**PCN # ESW490-43 – TO-277 Package Outline Change**

## Product/Process Change Notice (PCN)

**PCN#:** ESW490-43    **Date:** May 31st, 2022

Subject: **Qualification test result of TO-277 series product outline change**

**New TO-277  
outline**

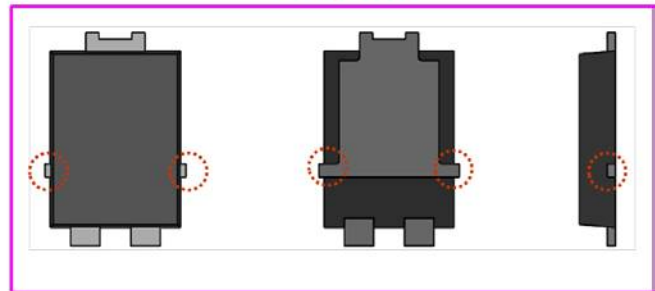
Littelfuse would like to notify you that we will slightly change the outline of TO-277 package, which will optimize the backend assembly efficiency and output which in the end increase the total capacity of Littelfuse TO-277 package to support customer increased demand in future.

**Form, fit, function changes:** small outline change but no footprint update needed (refer to qual report)  
**Part number changes:** None  
**Effective date:** Aug 31<sup>st</sup>, 2022  
**Replacement products:** N/A  
**Last time buy:** N/A

# 1. Change Description

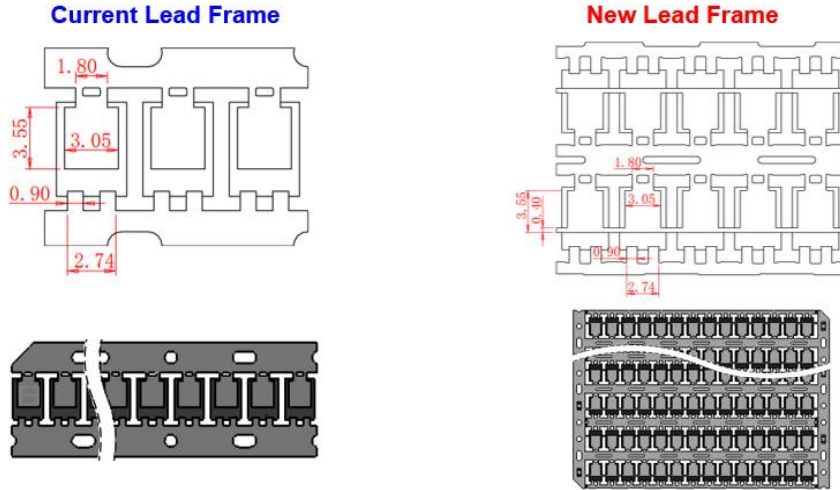
1.1 Re-design TO-277 series lead frame outline to increase lead Frame qty/piece from 40 pcs/piece to 226 pcs/piece.

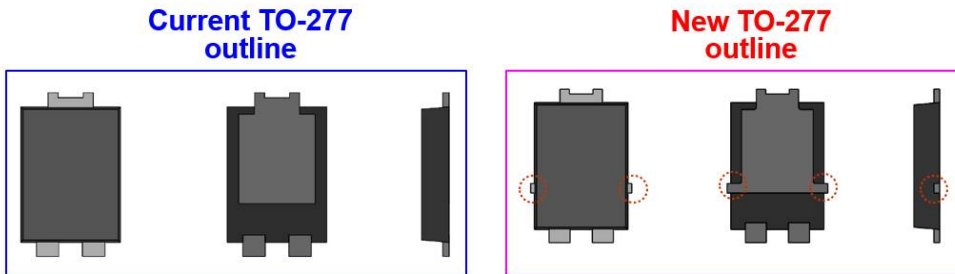
1.2 Re-design TO-277 series lead frame outline to solve the overflow issue through add new parts on both sides, it can make mold easy to flatten the surface of a material at molding process.

1.3 Dimension change description:

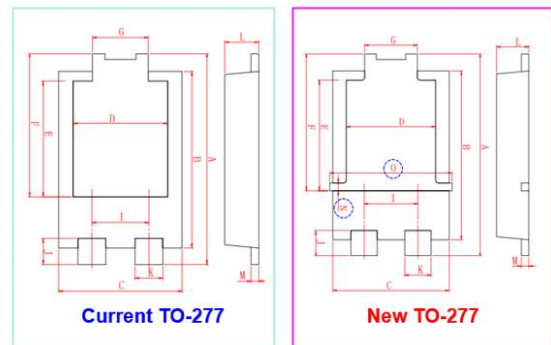
The "A" ~ "M" dimensions of the new TO-277 are the same as current TO-277, with new TO-277 add dimensions of "N" and "O".
